**UMMC PROJECT NO. 409-007
FIRE PROTECTION CENTRAL CORE
UNIVERSITY OF MISSISSIPPI MEDICAL CENTER
JACKSON, MISSISSIPPI**

Addendum No. 1

August 5, 2026

This addendum forms a part of the contract documents and modifies the original plans and specifications dated June 12, 2026.

sheet no.
FP601

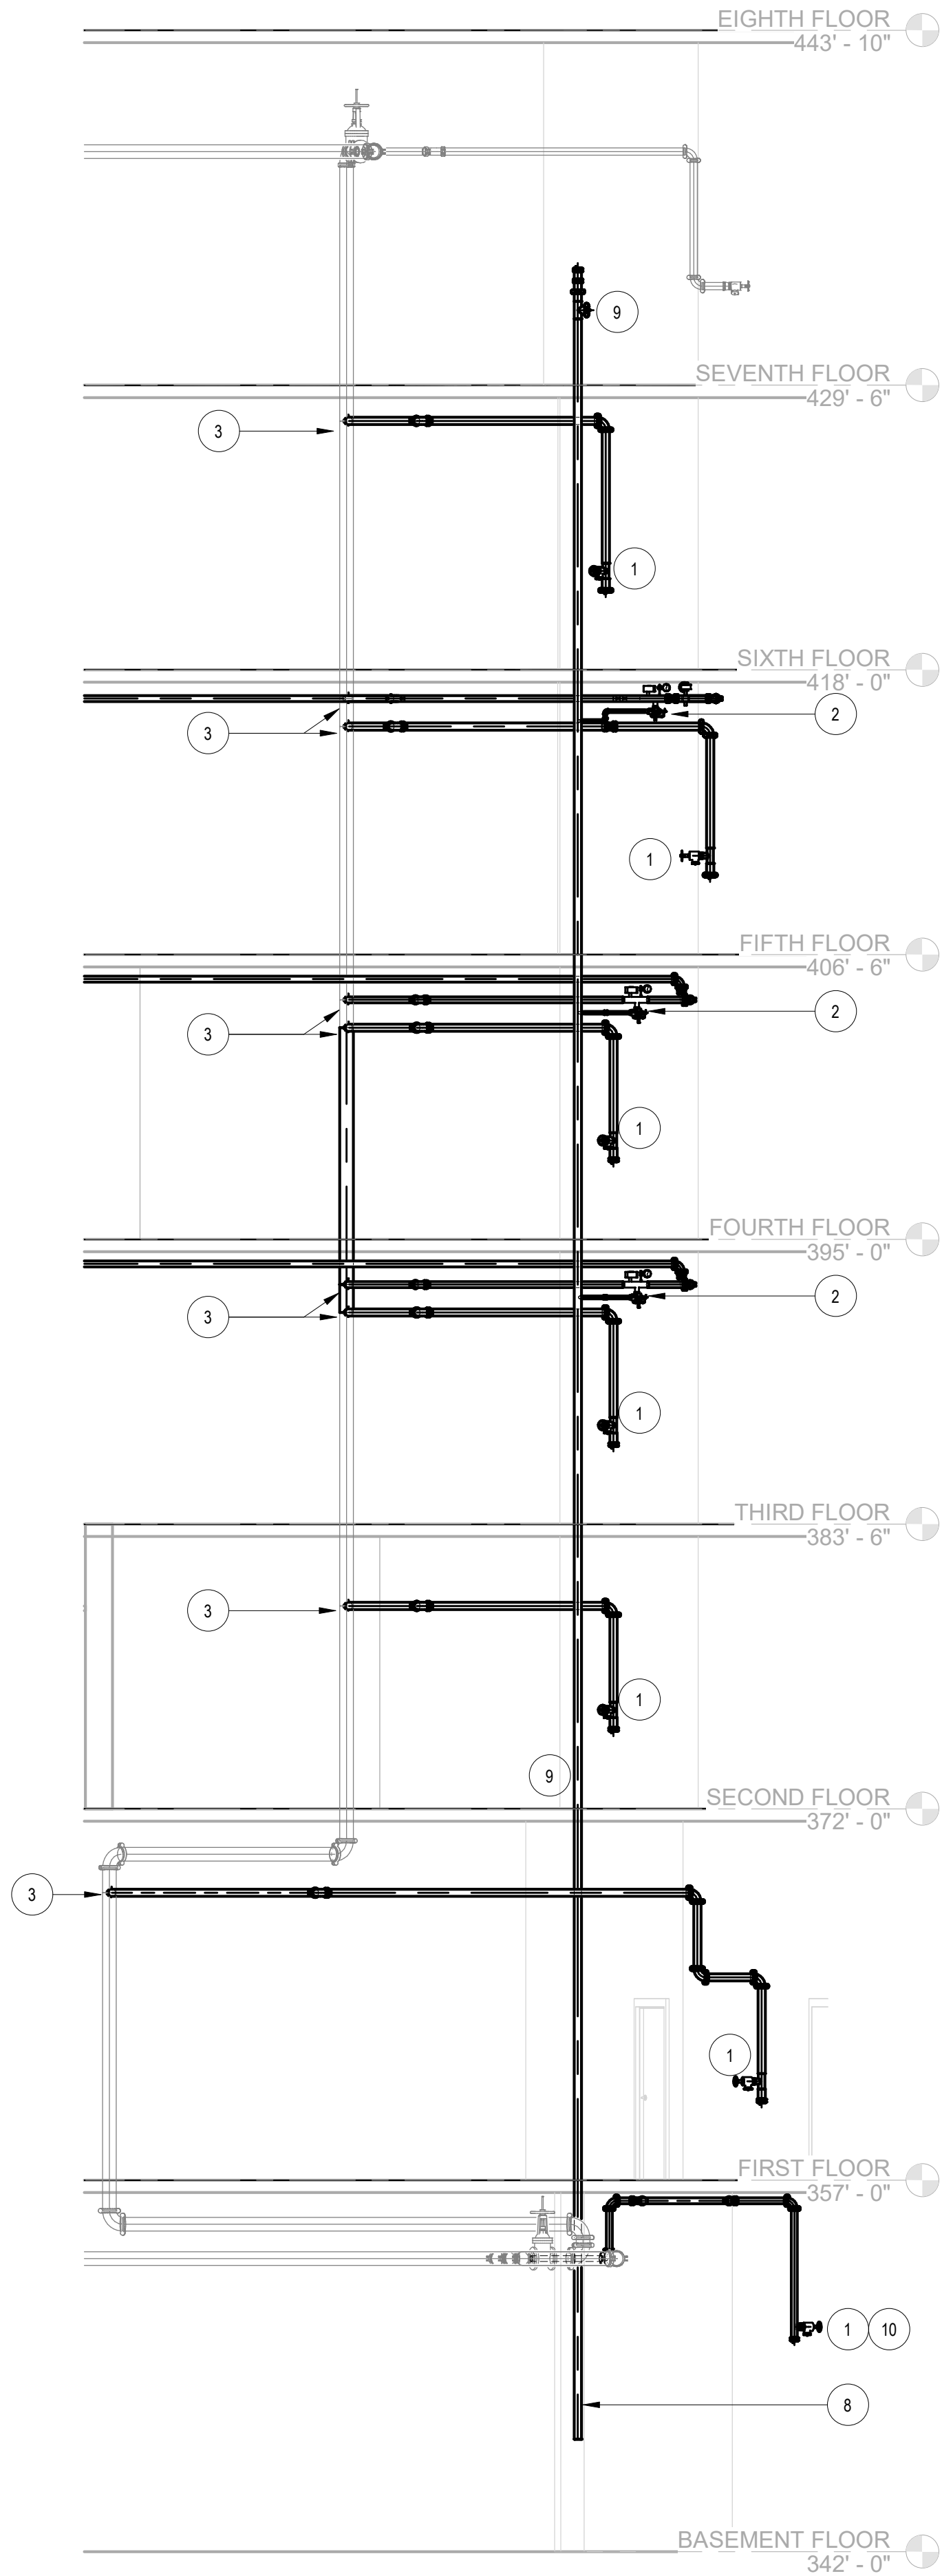
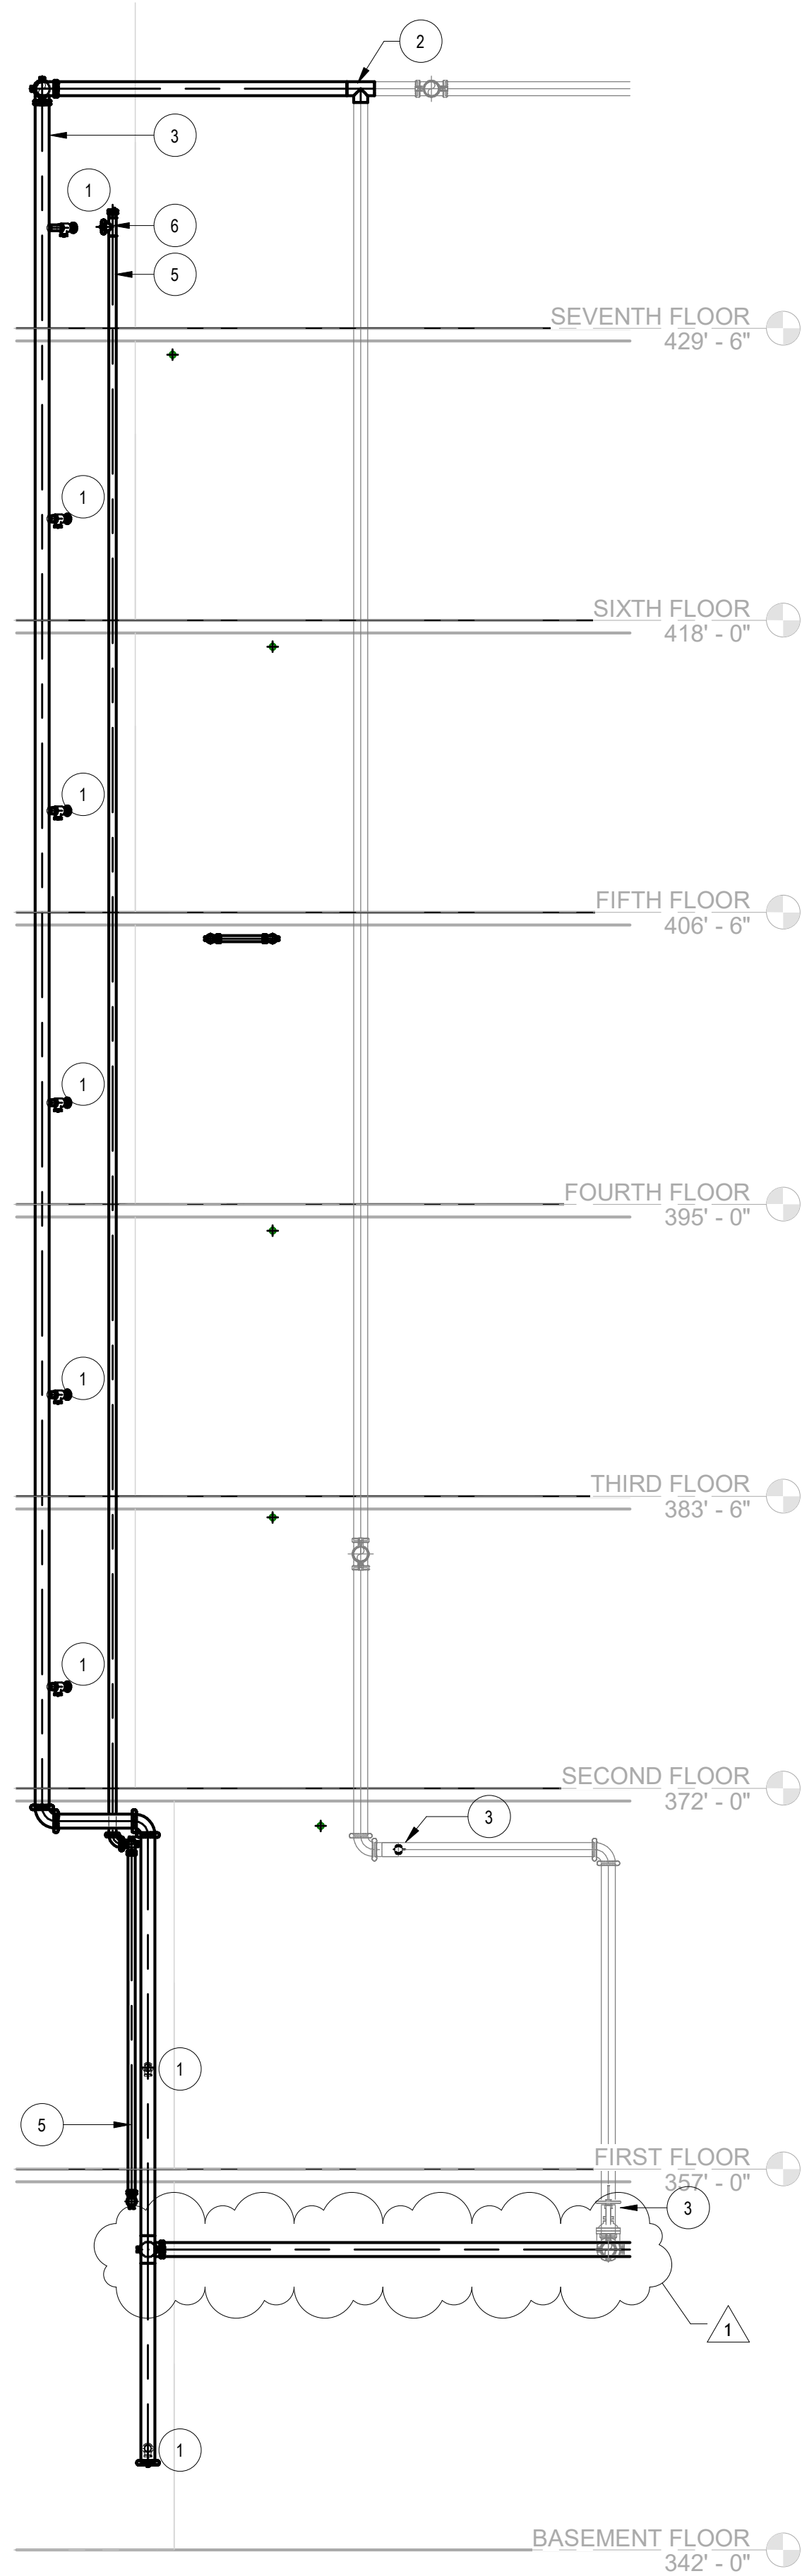
- 1. Keyed note #8 updated to make use of existing path of demolished 1" drain line for new 3" drain. Widen cored slab holes and wall penetrations where necessary.

- 7. REMOVE EXISTING DRAIN PIPING.
- 8. NEW 3" EXPRESS DRAIN. CONNECT IN NEW AND EXISTING ZONE VALVES DRAINS. ROUTE 3" EXPRESS DRAIN PIPE TO APPROVED DRAIN LOCATION USING EXISTING PATH OF DEMOLISHED 1" DRAIN LINE. WIDEN CORED SLAB HOLES AND WALL PENETRATIONS WHERE NECESSARY.

SECTIONS
sheet no.
FP602

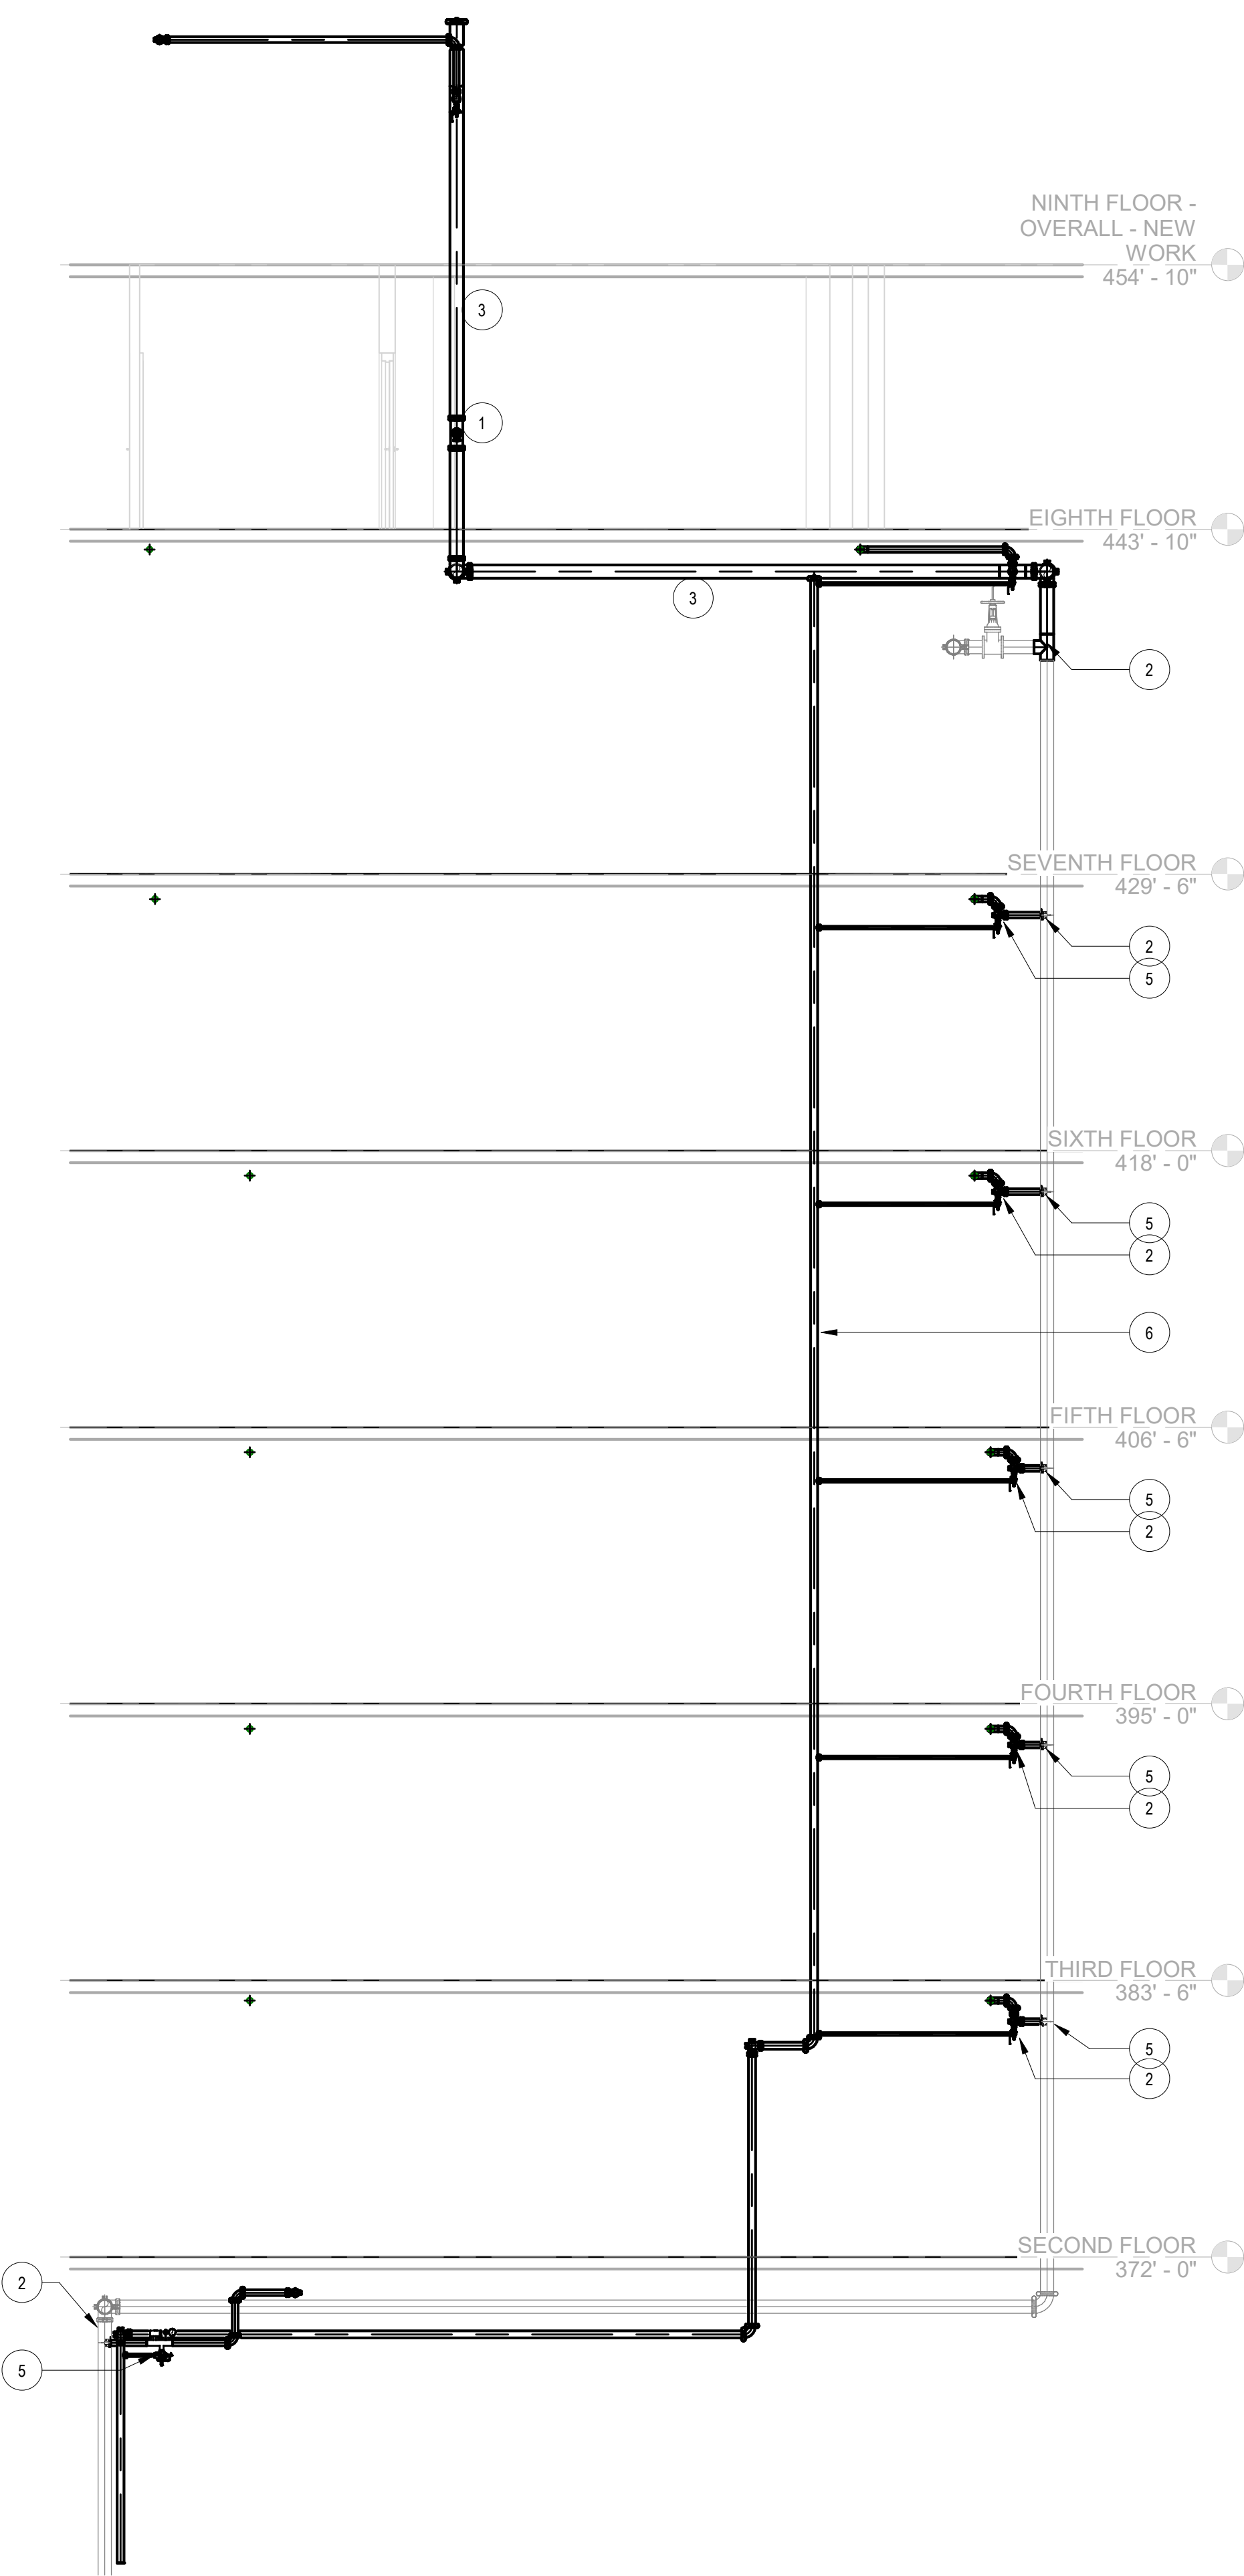
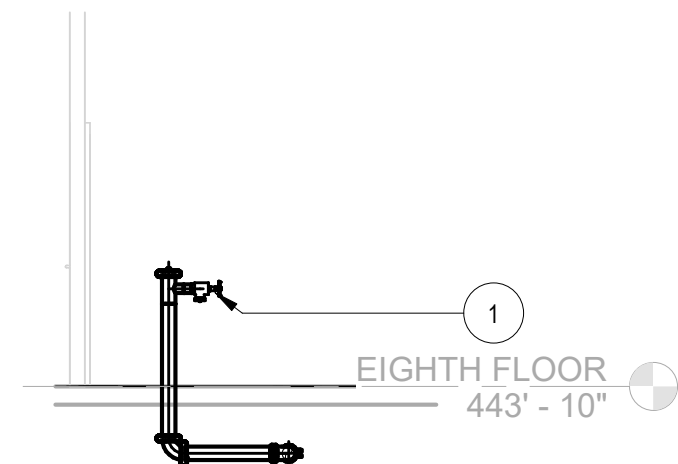
- H. Sheet FP602, Sections
 - 1. Stair N-01 new 6" standpipe connected into existing basement loop feed main.
